DEPARTMENT OF LAND UTILIZATION  
**CITY AND COUNTY OF HONOLULU**

Final Environmental Impact Statement (EIS)  
Hawaii Technology Park  
Oceanic Properties, Inc.  
Mililani, Oahu; Tax Map Key 9-5-02: Portion 11

ACCEPTANCE REPORT: CHAPTER 343, HRS  
ENVIRONMENTAL IMPACT STATEMENT (EIS)  
HAWAII TECHNOLOGY PARK  
OCEANIC PROPERTIES, INC.  
BELT, COLLINS & ASSOCIATES, AGENT  
TAX MAP KEY 9-5-02: PORTION 11  
MILILANI, OAHU, HAWAII

FIGURE 7  
INTERIM TRAFFIC CONDITIONS

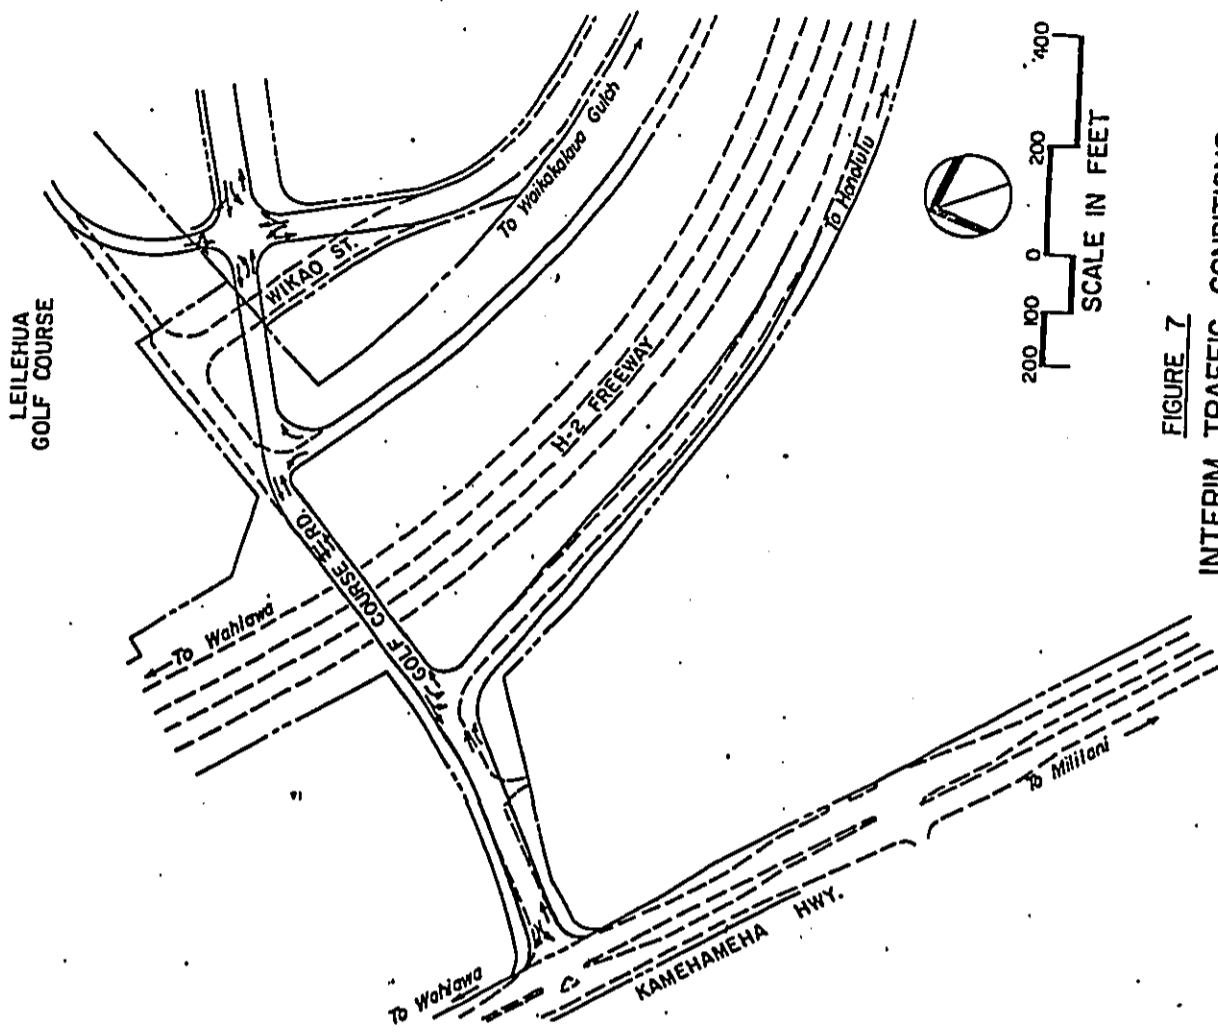
The attached copy of Figure 6 from the Traffic Impact Study report has been marked to show the inter-sections proposed to be signalized. An attached Figure 7 shows the interim traffic conditions, assuming that access to Lalehua Golf Course be provided opposite Wikao Street.

a. If the proposed traffic changes detailed in appendix 2 (Traffic Impact Study) to the EA are implemented, we have strong reservations concerning the safety and adequacy of the vehicular access to and from Leilehua Golf Course. Based on the proposed road realignments shown on Figure 6, it does not appear that there will be sufficient distance for a vehicle to safely proceed from the intersection of the Golf Course Road and the H-2 freeway off-ramp (northbound), across three lanes of traffic, and into the lane leading to Leilehua Golf Course. A more direct alignment to the golf course should be considered, possibly a route near the intersection where traffic from the H-2 off-ramp (northbound) will turn left and be westbound on the Golf Course Road. Further, the study should indicate on Figure 6 the intersections which are proposed to be signalized. Because the proposed intertia improvements (p. 10-11 of appendix 2) may be implemented during year one of the development and maintained at least for 6 - 8 years, the inclusion of a figure depicting the various traffic changes would greatly assist in evaluating possible project impacts.
